## NOTICE OF ADDENDUM NO. 1

State of Rhode Island  
Solicitation Number 7553498  
CBLS Cooling Tower Improvements  
University of Rhode Island  
Kingston, Rhode Island

**DATE OF ADDENDUM:**                    **June 9, 2017**

# APPENDIX A

**TRENCH DRAIN DETAILS**  
NOT TO SCALE

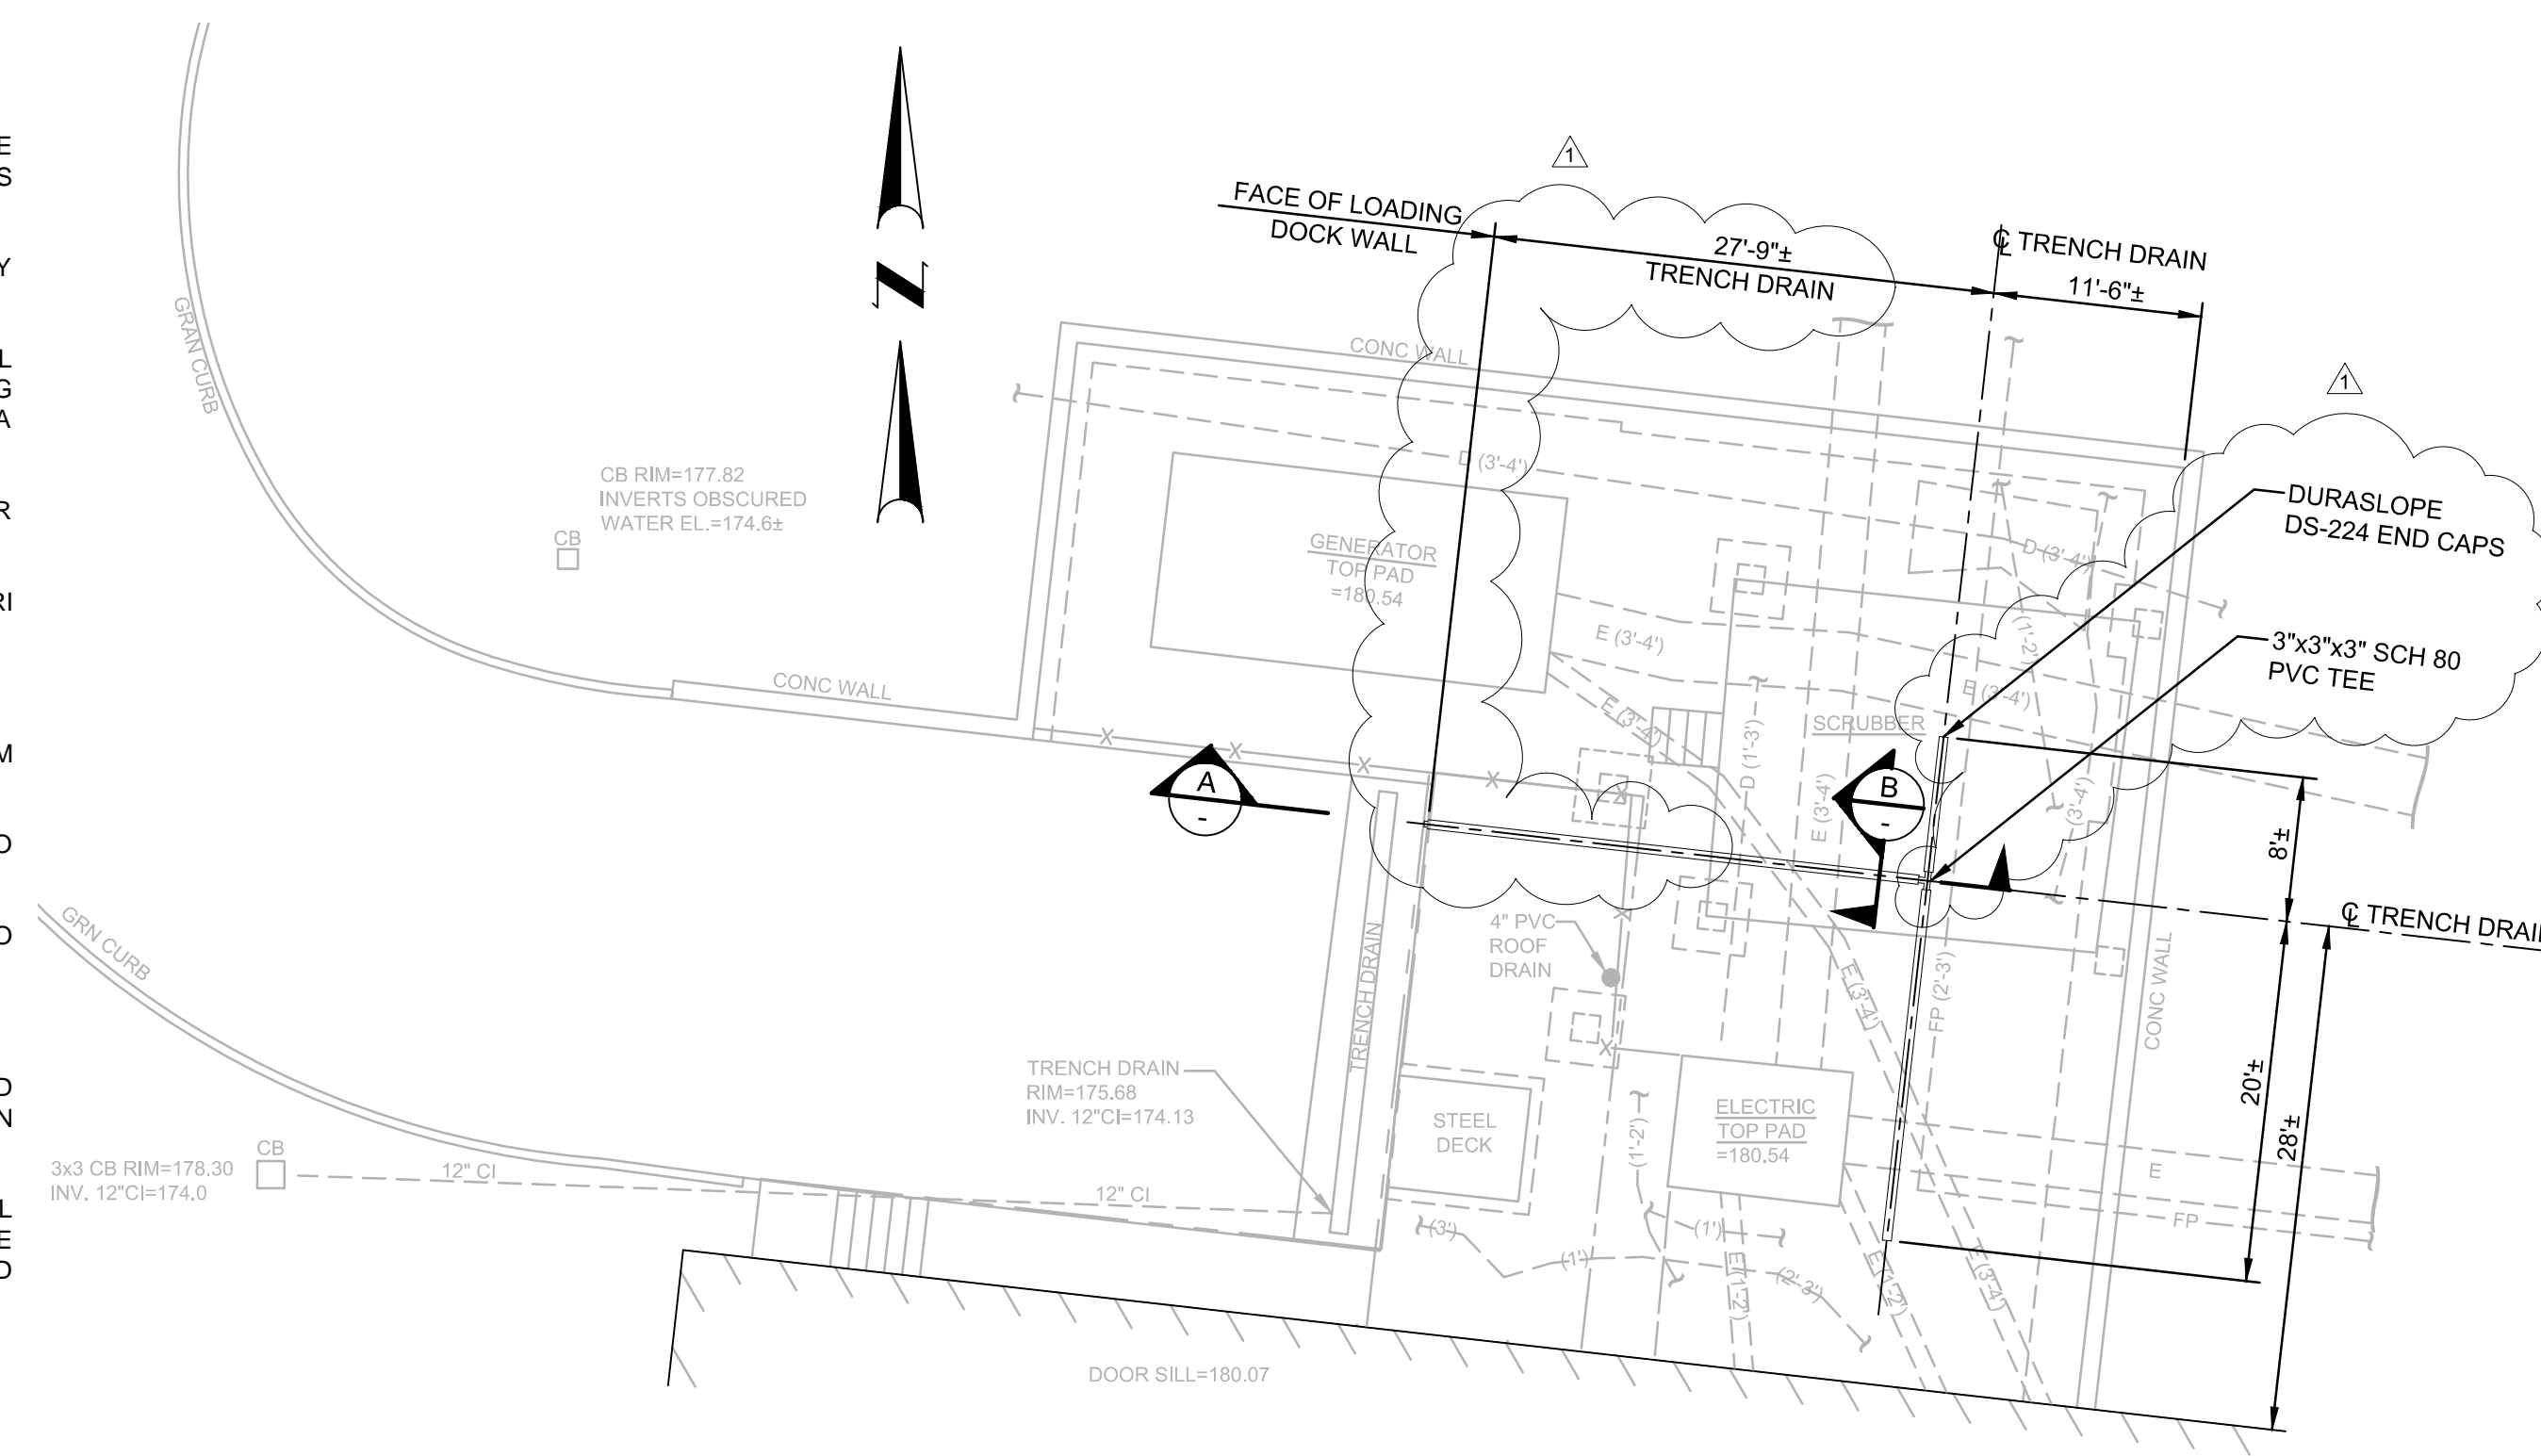
1. Delete Drawing No. 3, Sheet 3 of 3 and replace with attached Drawing No. 3 (Addendum No. 1).
2. Insert Appendix A - This section covers the installation of a new Fall Protection system at the Level Four Green Roof. The scope of work includes removal of existing roofing, creating openings through existing roof deck at roof anchor locations, installation of new Fall Protection System, enclosing roof deck and reinstalling new roofing at roof openings.

**SKA-1**

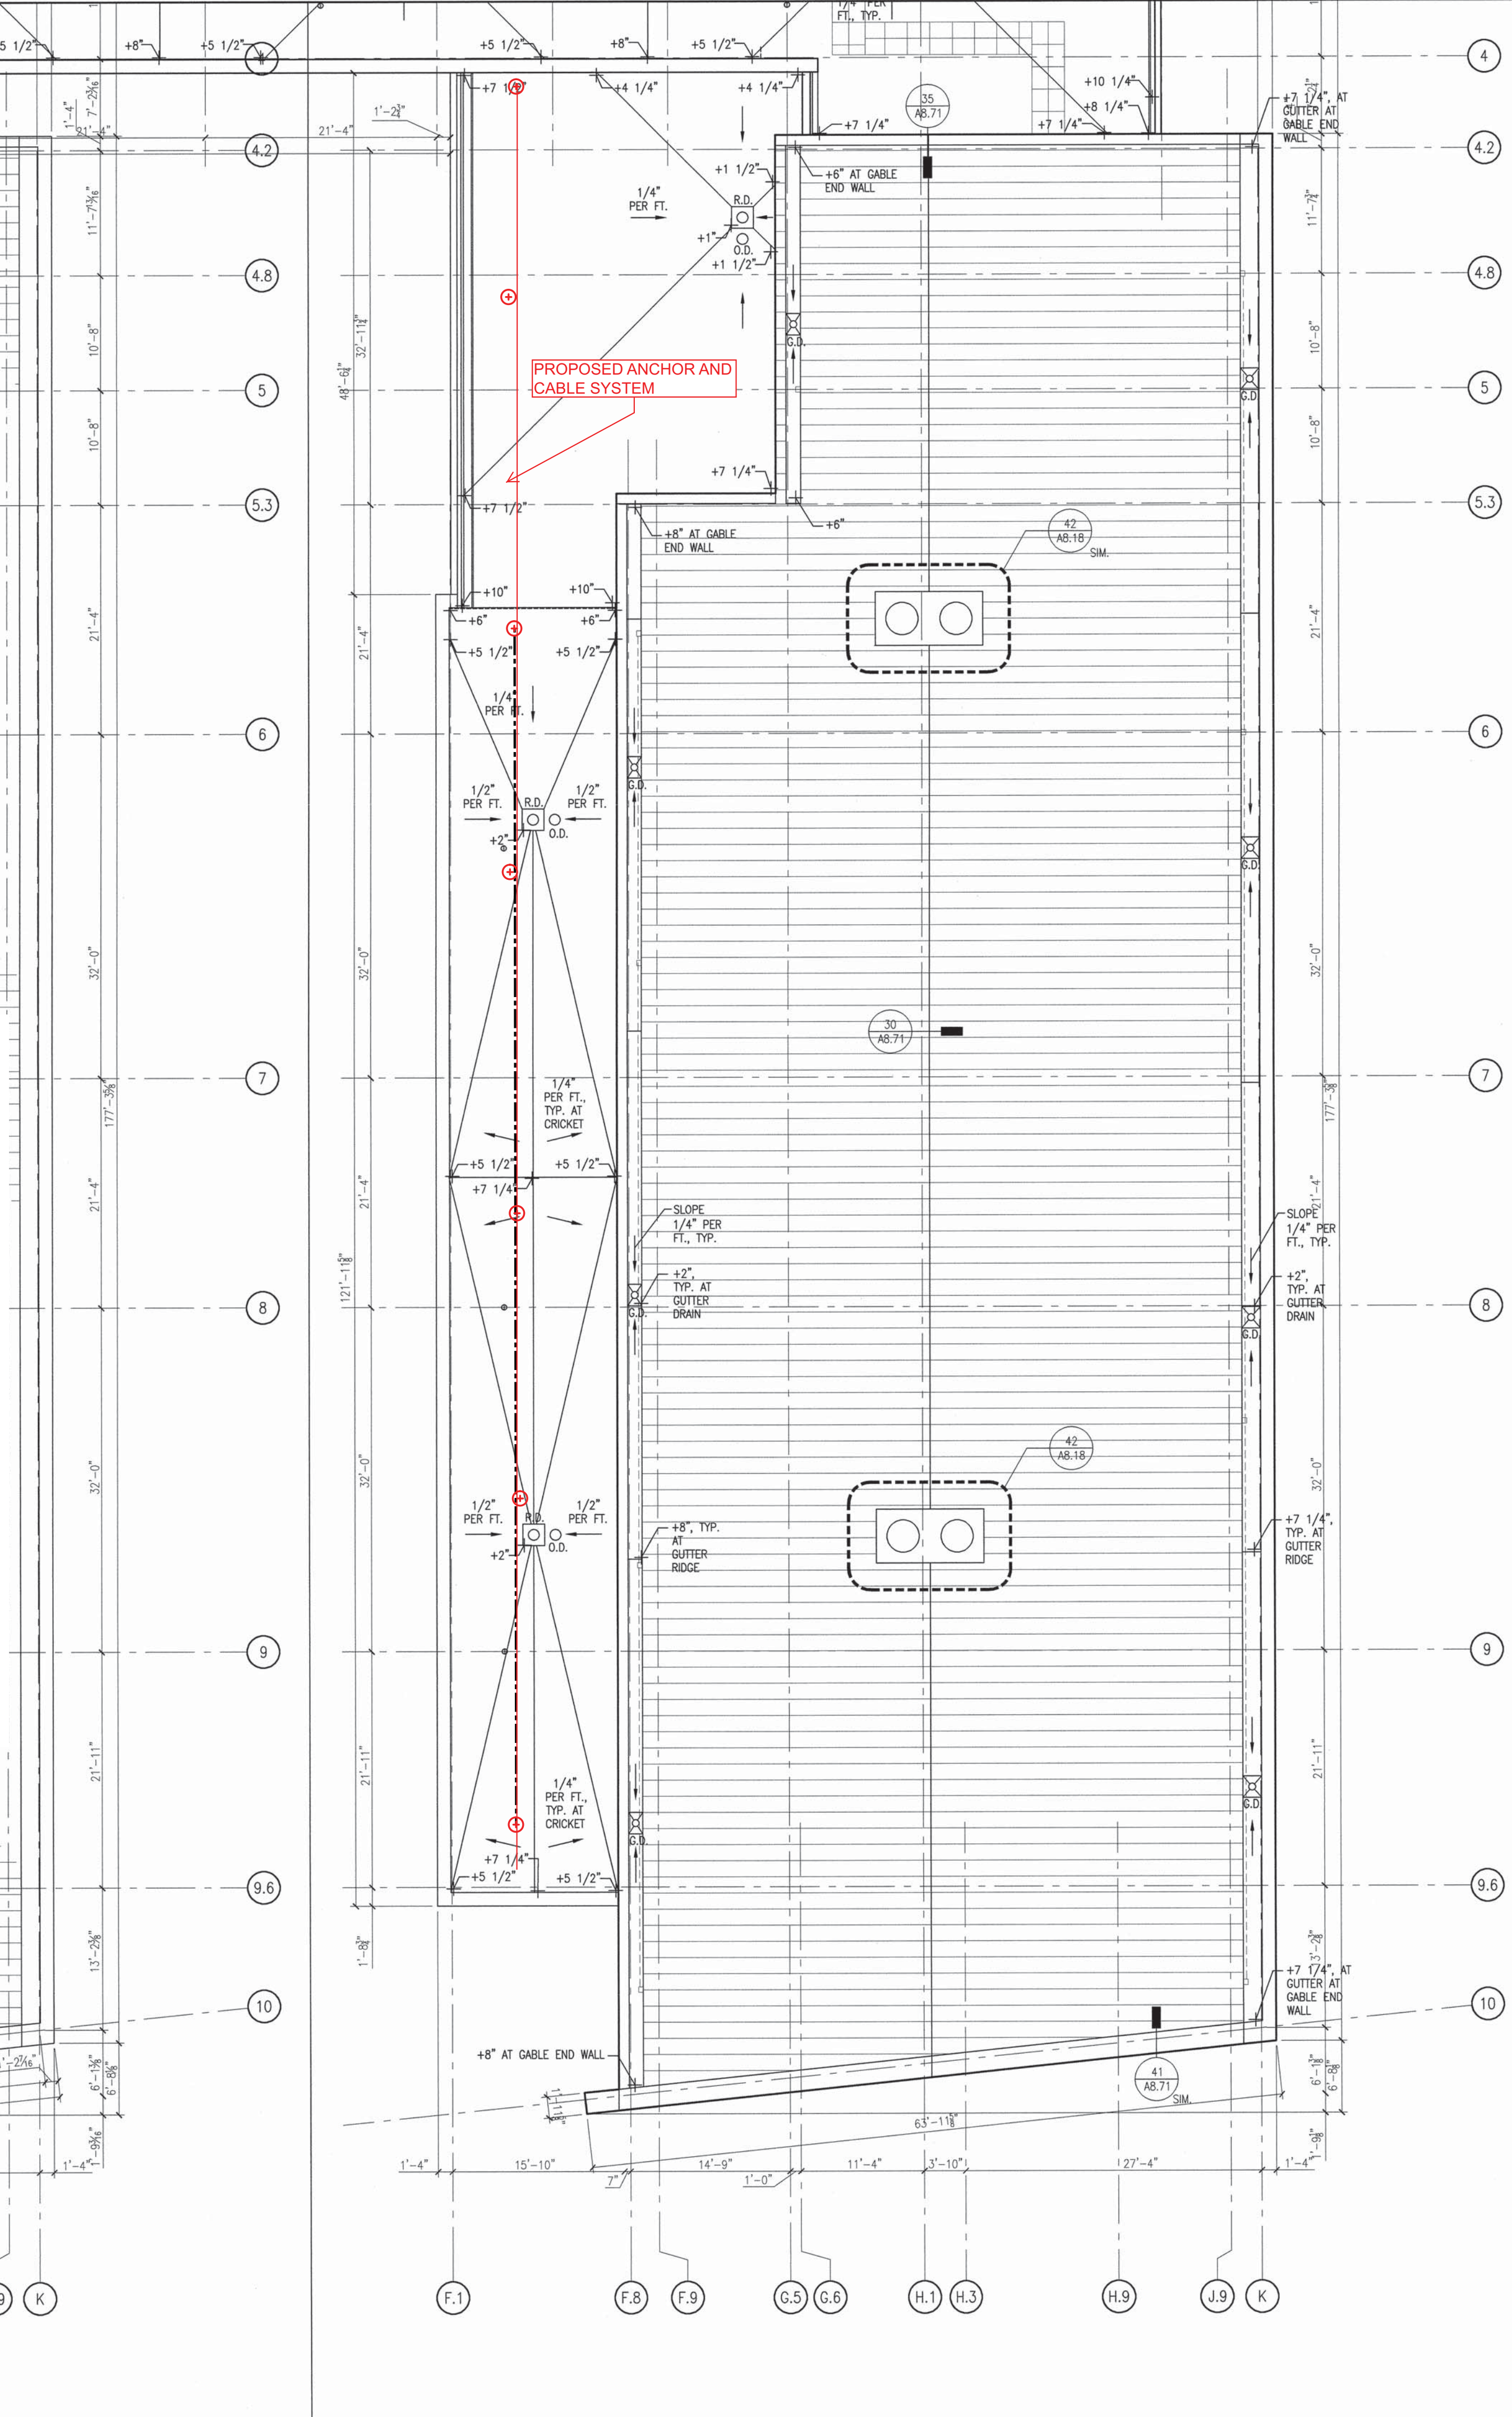
**Notes:**  
 For installation of New Fall Protection System:  
 - Remove existing roofing at locations identified to receive new roof anchors;  
 - Create openings in existing roof deck;  
 - Install roof fall protection anchor system per manufacturer's requirements;  
 - Repair roof deck - provide drawings for review and approval by structural engineer;  
 - Repair roof membrane, protection board, membrane flashing and green roof assembly at all roof openings to match original conditions.
